Technical Note TN-857-SR TM8000 Mobile radio Release 3 and Upgrade Instructions

10 May 2004

This Technical Note details the changes in Firmware and PC Application in Release 3, and instructions on upgrading existing TM8100 radios to Release 3.

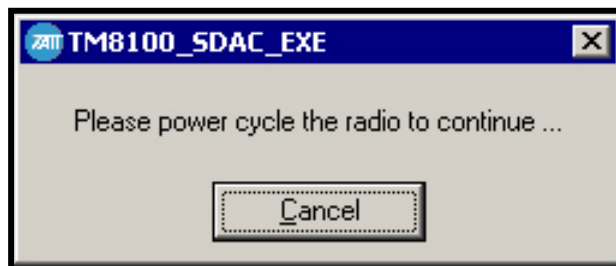
From radio serial number **19009872** all radios built have Release 3 Firmware.

Do NOT upgrade Demo / Field Trial (DMABxx) radios with serial numbers prior to **19001450** to Release 3, this will render the radio inoperable.

To upgrade production TM8100 Firmware to Release 3:

- Upgrade the Calibration and PC Application versions to Release 3 or later. These are:
 - PC Application v2.66.00.06
 - Calibration Application v2.65.00.08
- Read and save the radio's personality (data file)
- Read and save the radio's calibration
